**HORIZONTAL DIRECTIONAL DRILL ANALYSIS  
SUSQUEHANNA RIVER CROSSING  
PADEP SECTION 105 PERMIT NOS.: E67-920 and E22-619  
PA-YO-0063.0000-RR-16  
(SPLP HDD No. S2-0280)**

This reevaluation of the horizontal directional drill (HDD) installation of a 16-inch diameter pipeline that traverses under the Susquehanna River has been completed in accordance with Stipulated Order issued under Environmental Hearing Board Docket No. 2017-009-L (Order). During drilling of the first HDD and installation of the 20-inch diameter pipeline, an inadvertent return (IR) was identified during the pilot phase intersect from the East HDD unit; therefore, the second HDD requires reevaluation in accordance with the Order. The first HDD and 20-inch pipeline installation was initiated before the issuance of the Order.

### **REDESIGNED HORIZONTAL DIRECTIONAL DRILL DESIGN SUMMARY: 16-INCH**

Figure 1. Original 16-Inch HDD Plan and Profile

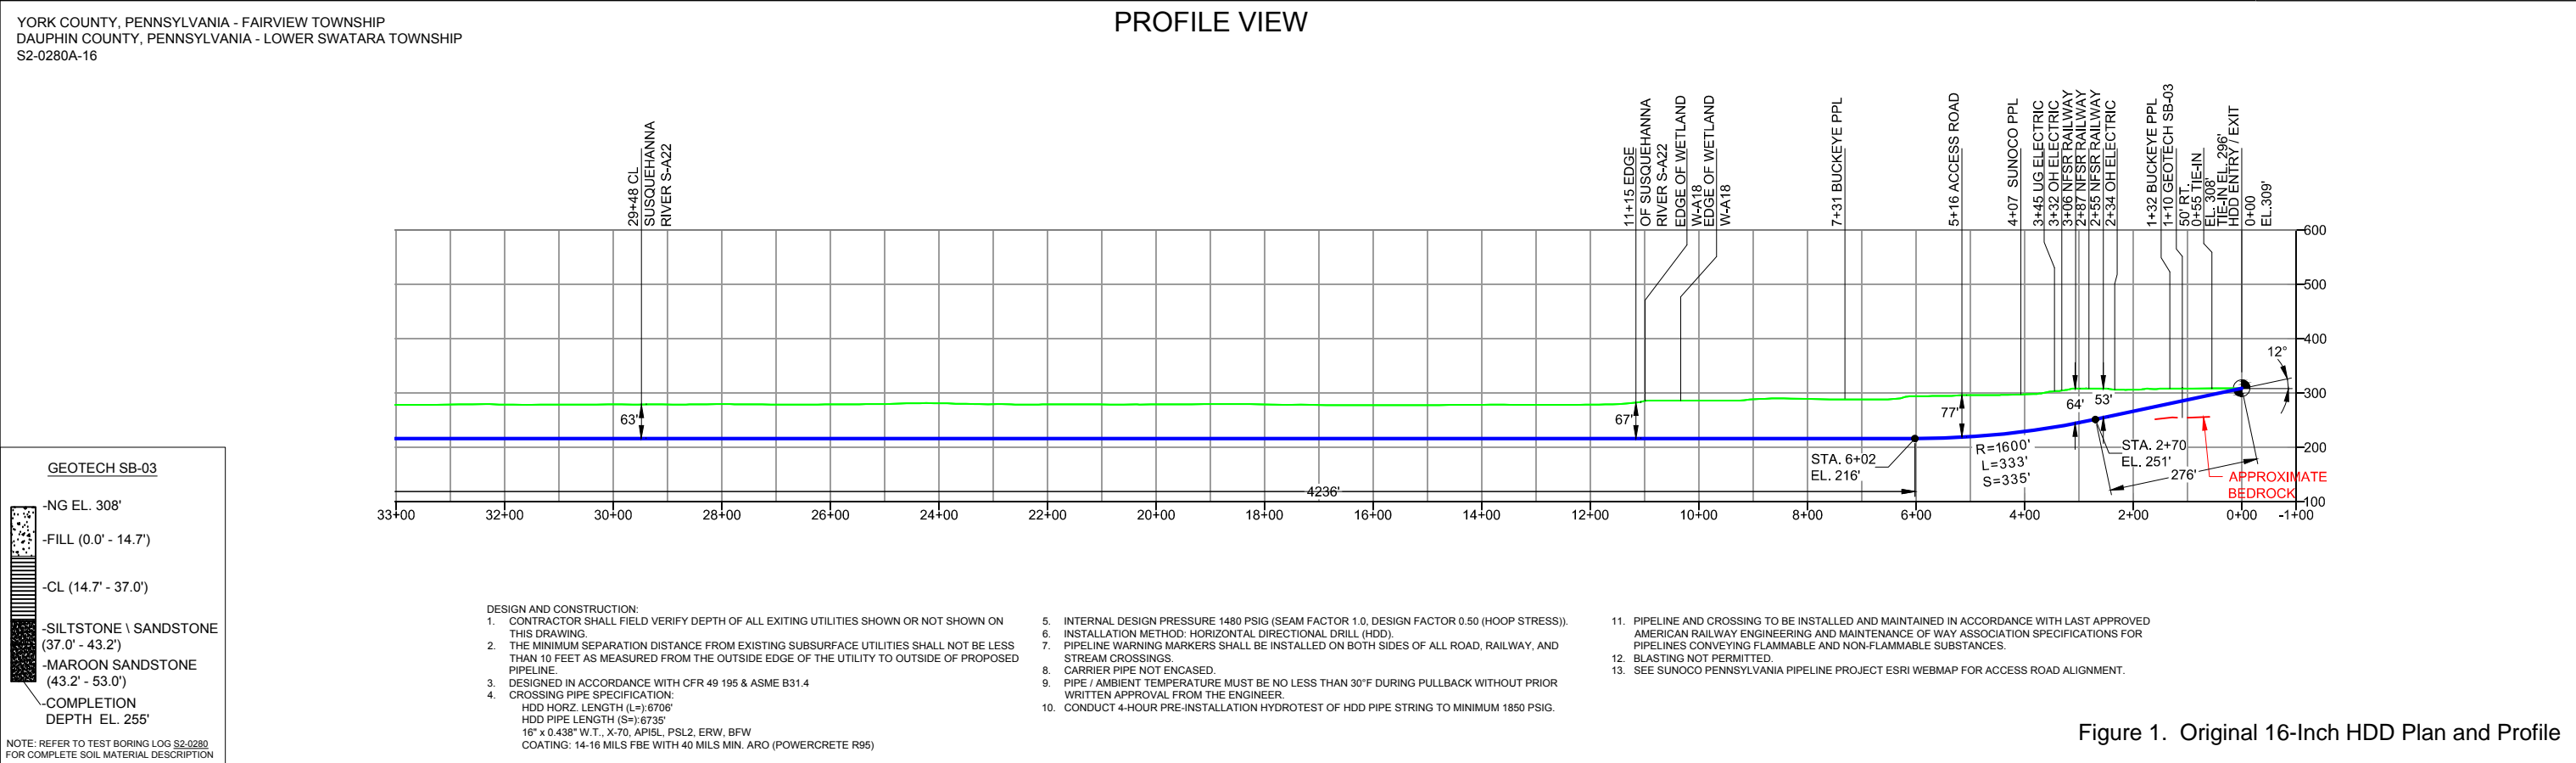
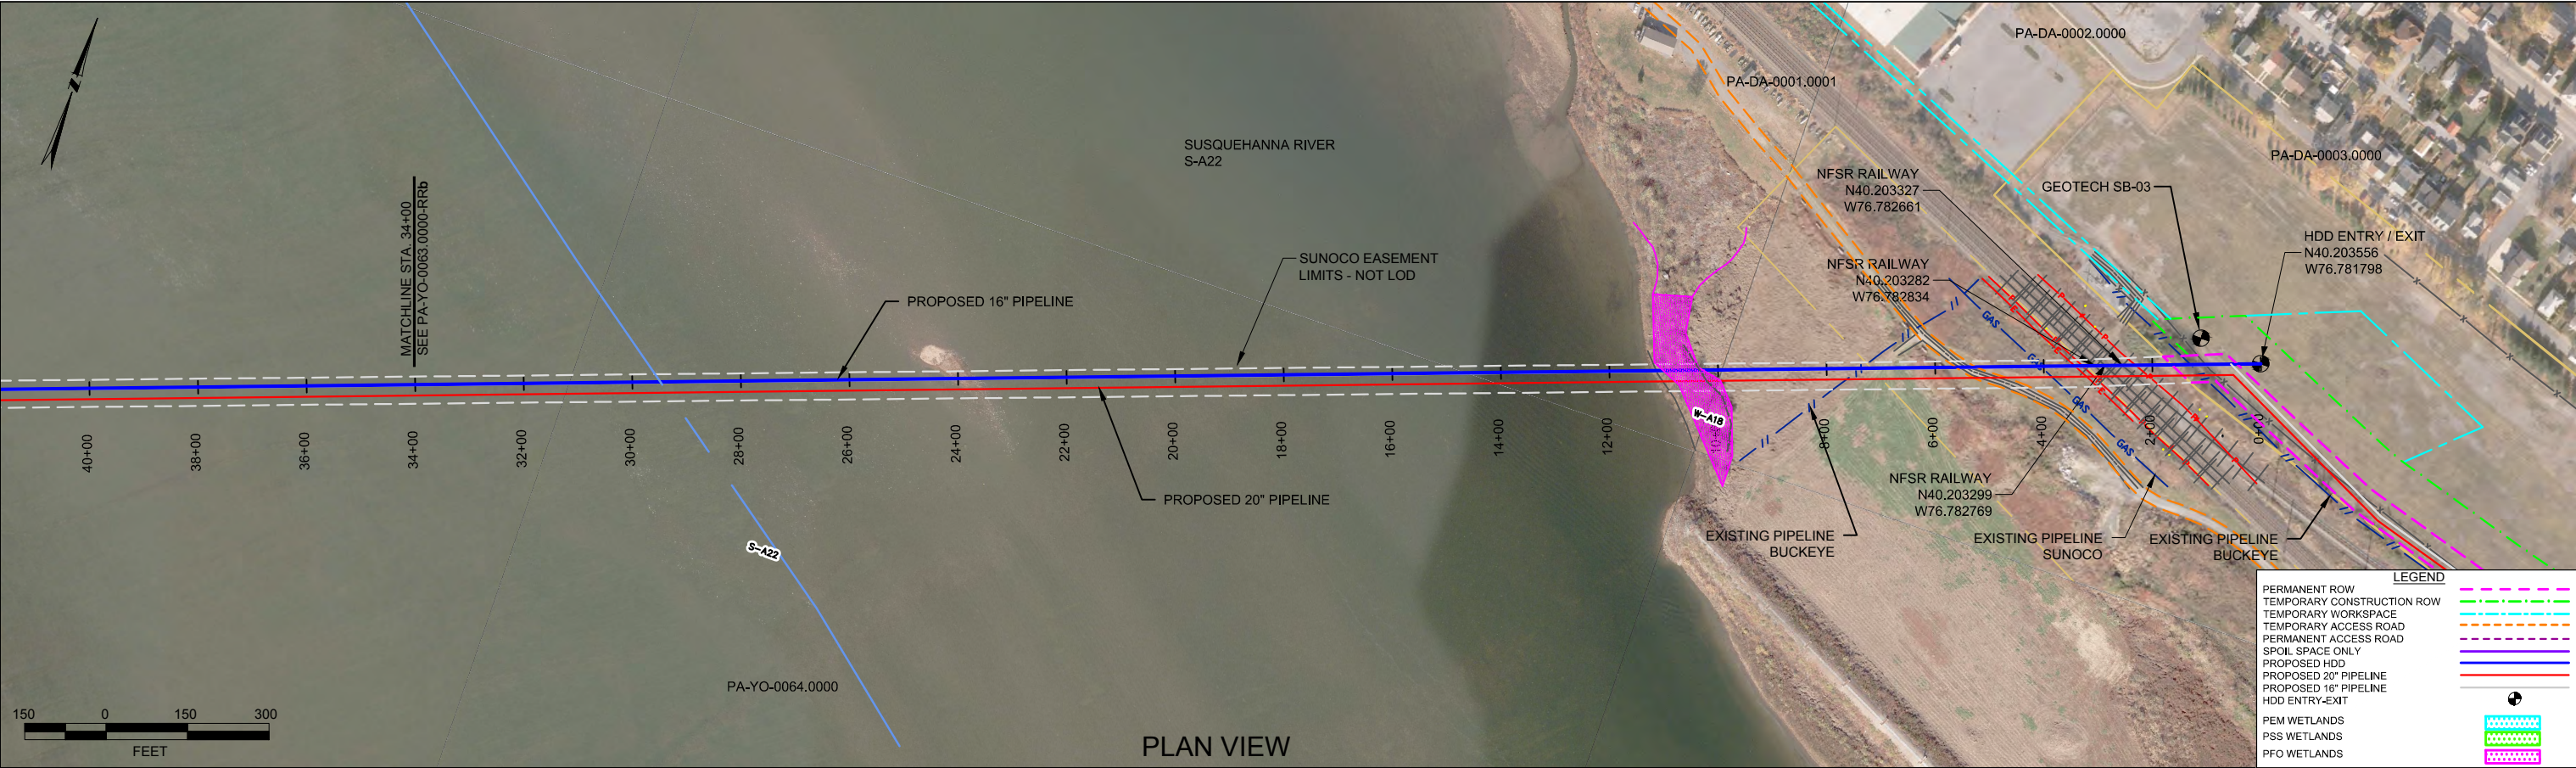
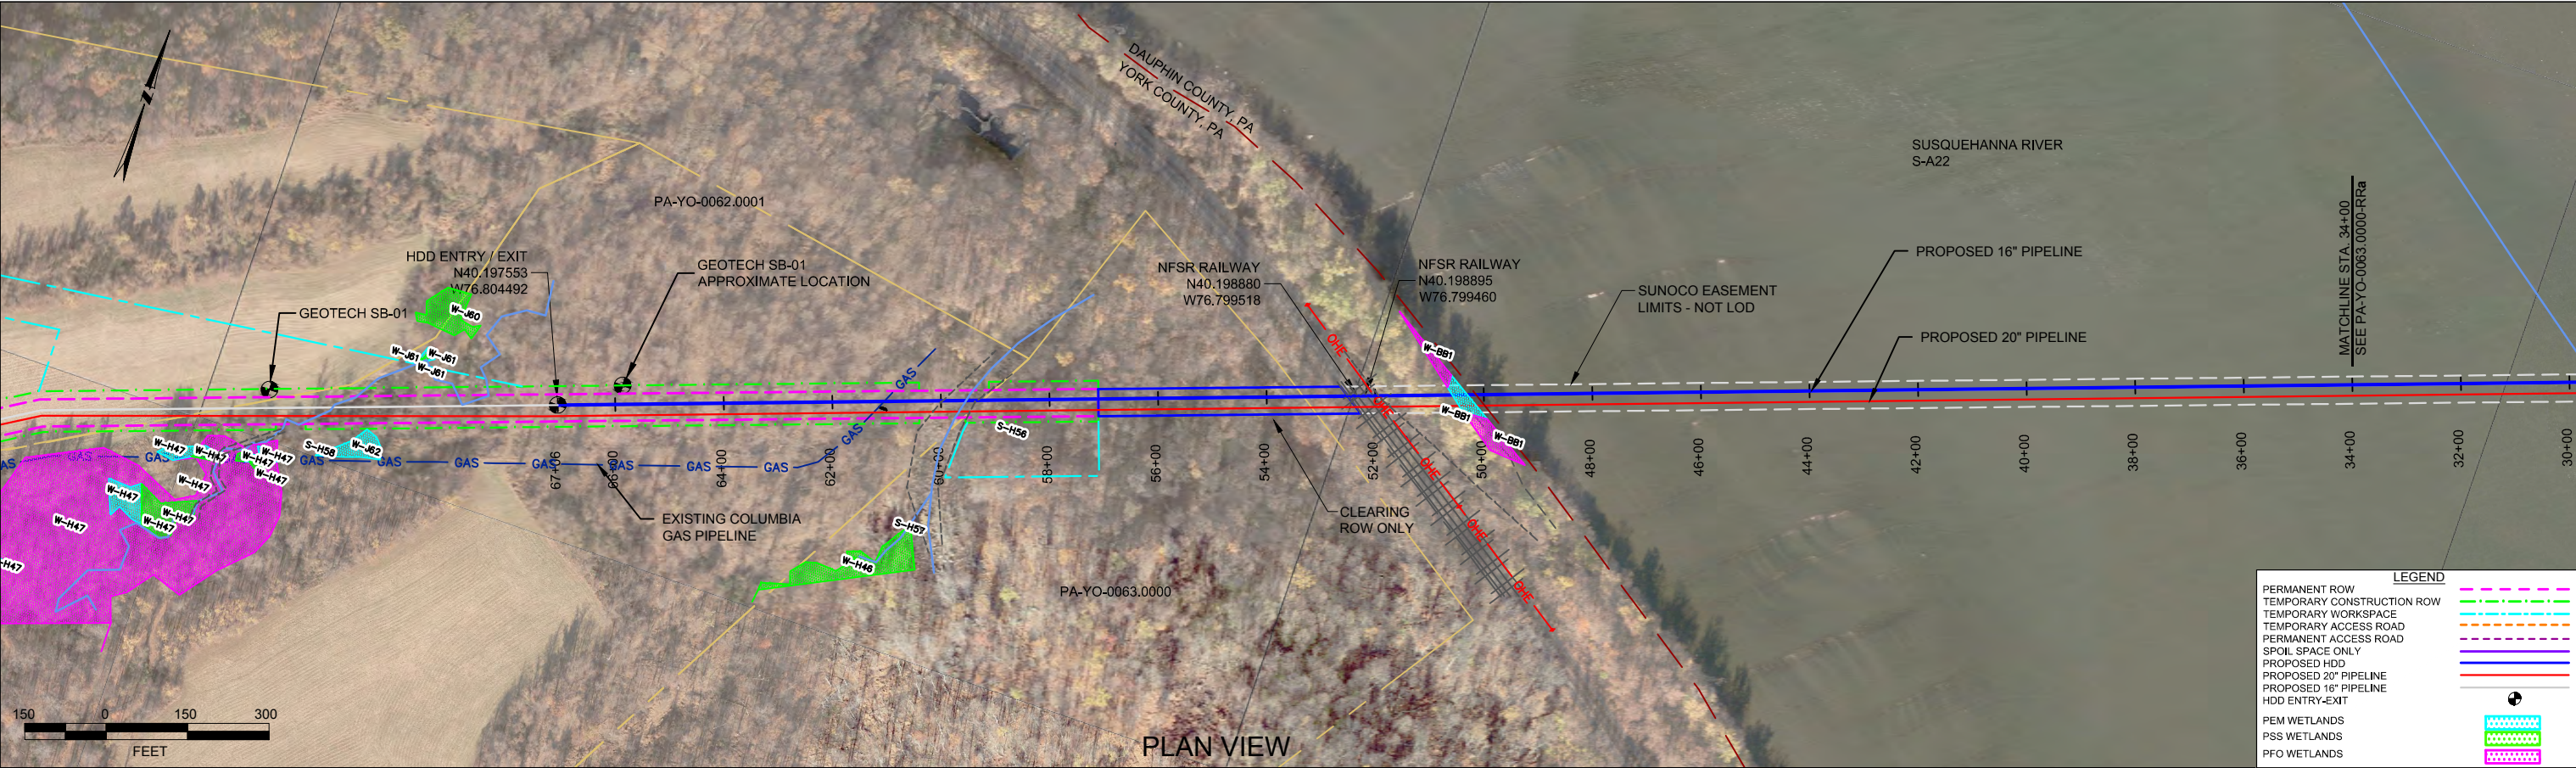
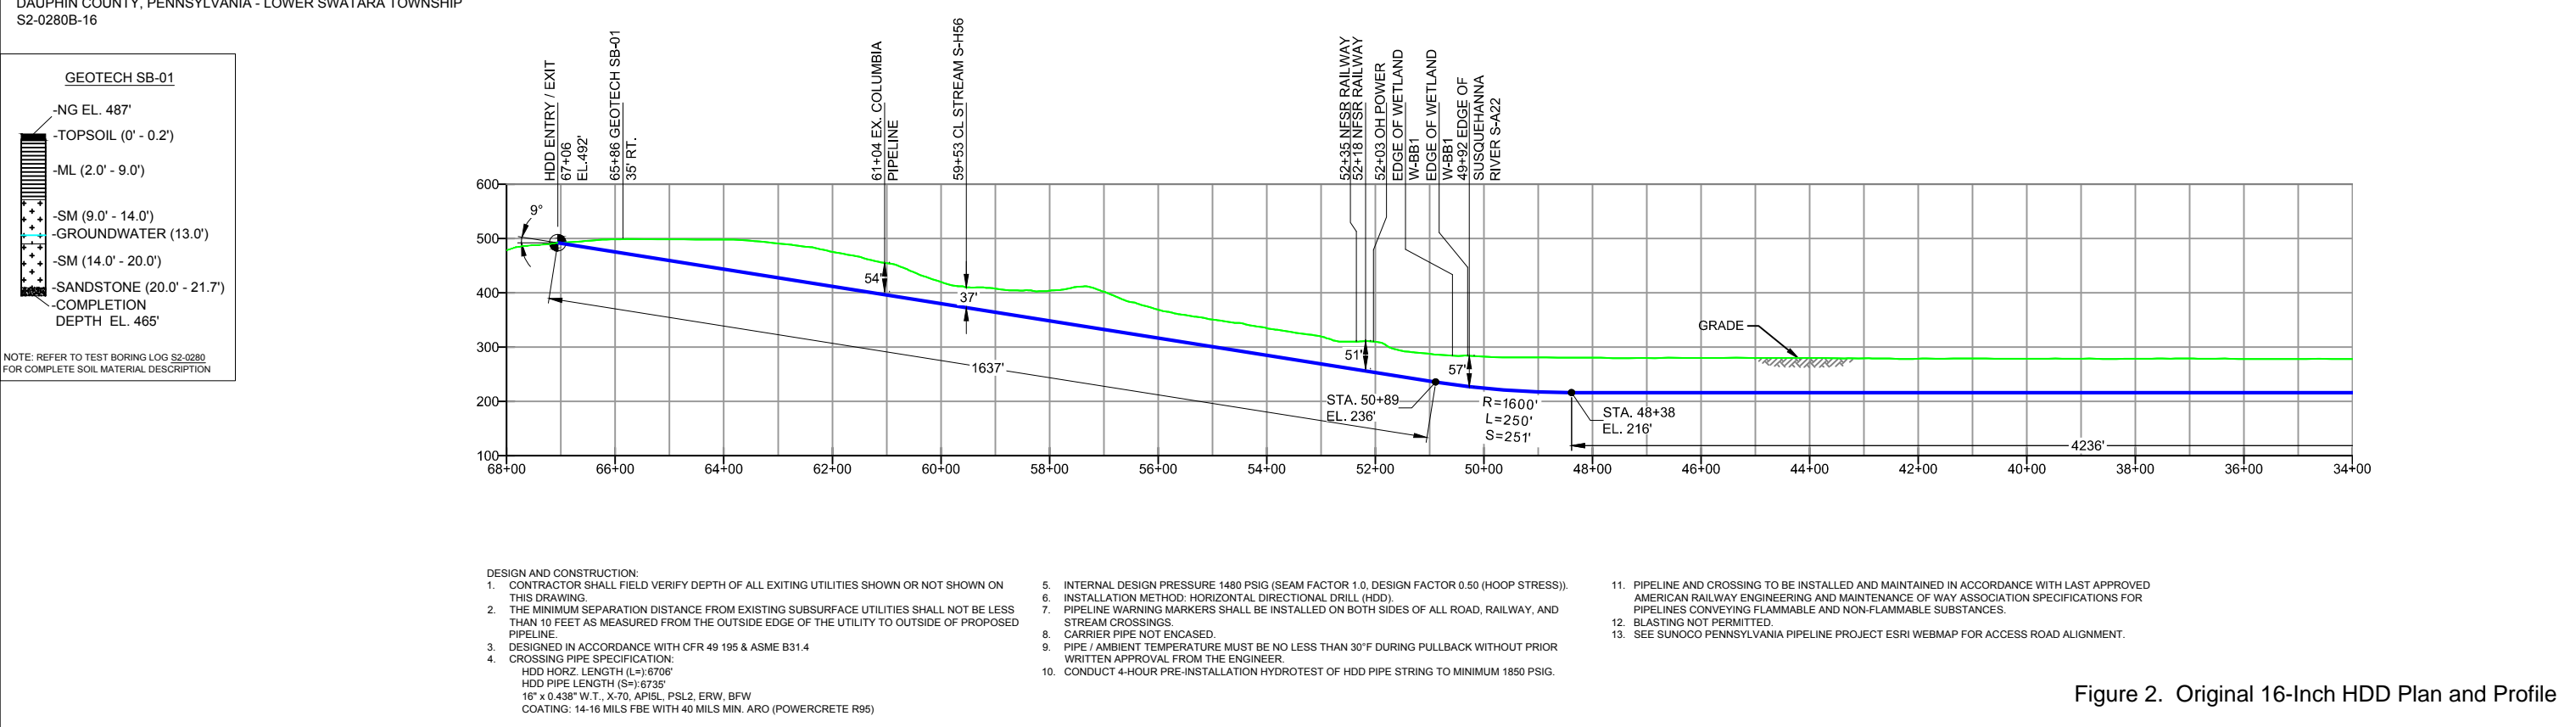
- Horizontal length: 7,380 ft.
- Entry/Exit angle: 13-15 degrees
- Maximum Depth of cover: 245 ft.
- Depth below Susquehanna River: 113-131 ft.
- Pipe design radius: 2,000 ft.

The 16-inch HDD profile has been re-designed to allow for a deeper crossing beneath the Susquehanna River than was completed for the 20-inch pipeline installation. The inclination of the entry and exit angles has been increased in order to install the 16-inch pipe through protective soils, residual soils, and bedrock in closer proximity to the entry and exit points than the original, shorter and shallower profile. From a geologic

It is SPLP’s intent to modify the original profile design and to pursue a deeper and longer HDD profile. Figures 1 and 2 in Attachment 2 presents the original permitted HDD plan and profile. Figures 3 and 4 present the revised HDD plan and profile.

perspective, the longer and deeper profile, in conjunction with the proposed engineering controls and/or drilling best management practices, will be used to reduce the risk of an IR.
